Customs Convention on the International Transport of Goods under Cover of TIR Carnets (TIR Convention, 1975):

Amendment proposals to the Convention: Vehicles with sliding sheets

Vehicles and containers with sliding sheets

Submitted by the International Association of the Body and Trailer Building Industry

Sketch No.10.2

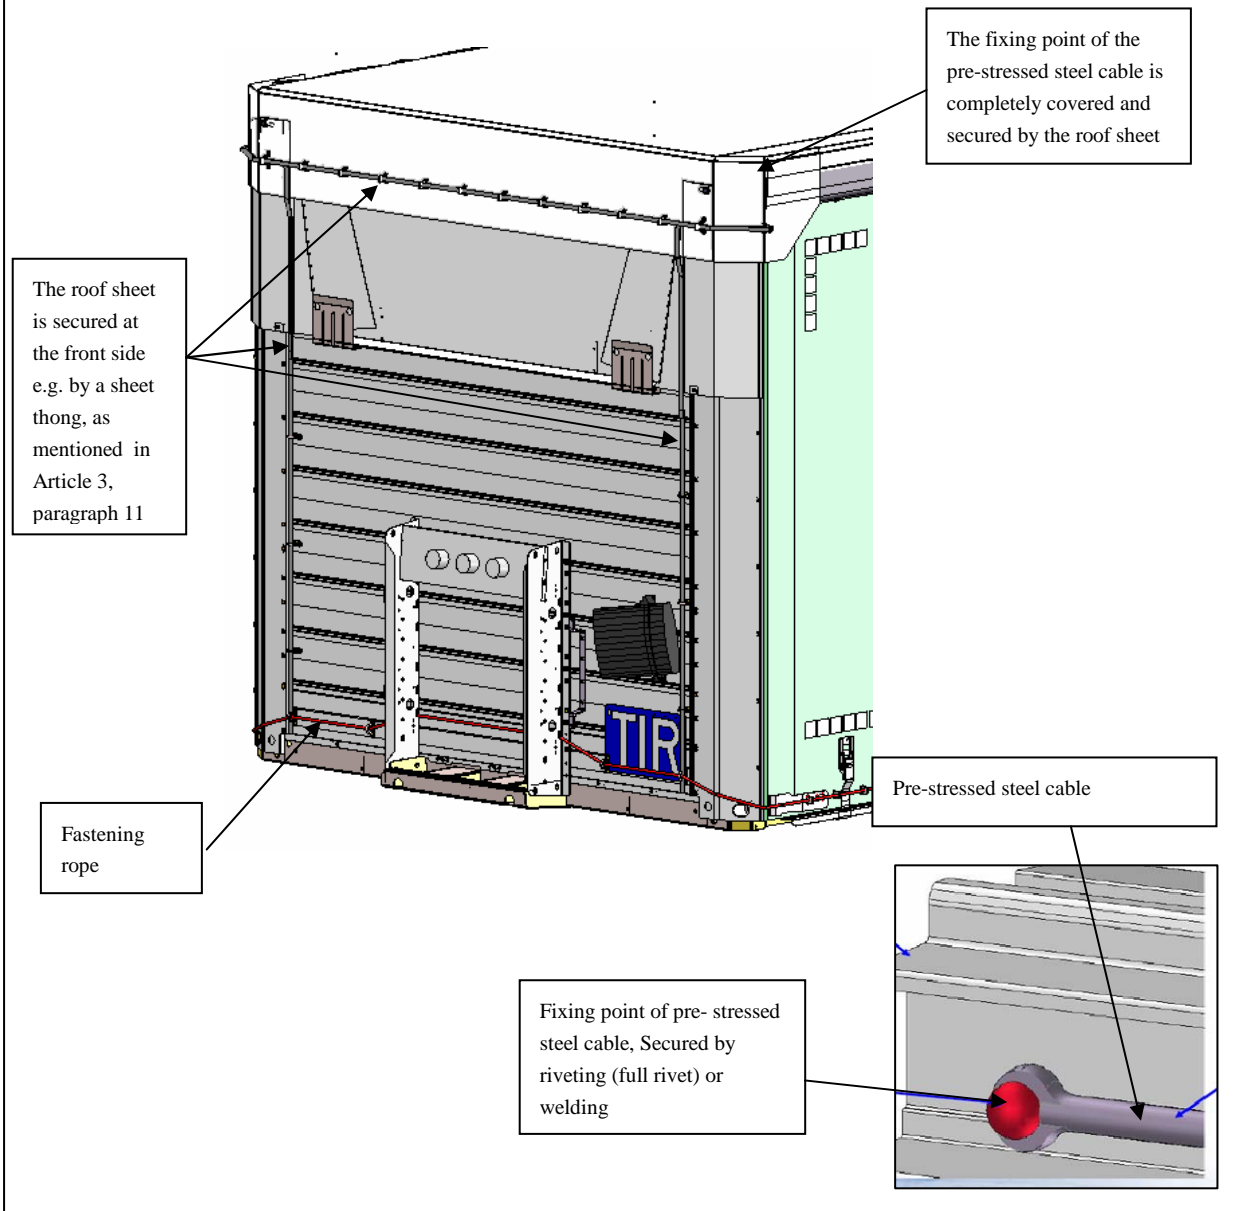
13. Add the following new sketch to the existing sketches appended to Annex 2

The sliding roof sheet shall overlap with the solid part of the roof at the front side of the container, so that the roof sheet cannot be pulled over the top edge of the upper cantrail
